# VKBD 0154

Technical Bulletin – December 2015

**FORD:** ESCORT V/ VI/ VII, FIESTA III, KA

MI-542627

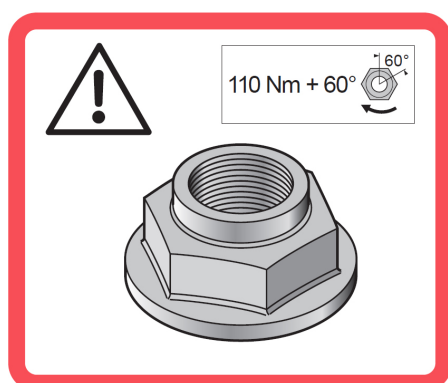
SKF has decided to change the nut in VKBD 0154, due to updated FORD OE recommendations.

**Note:** The included nut at kit VKBD 0154 has a new design and needs a different torque compared to the old design. It is crucial to follow the instructions when torquing the new nut since this is a **safety aspect**. See torque values stated at the warning label below.

Caution, when fitting the wheel bearing kit VKBD 0154, it's mandatory to use the new nut included in the kit. Never reuse an old nut!
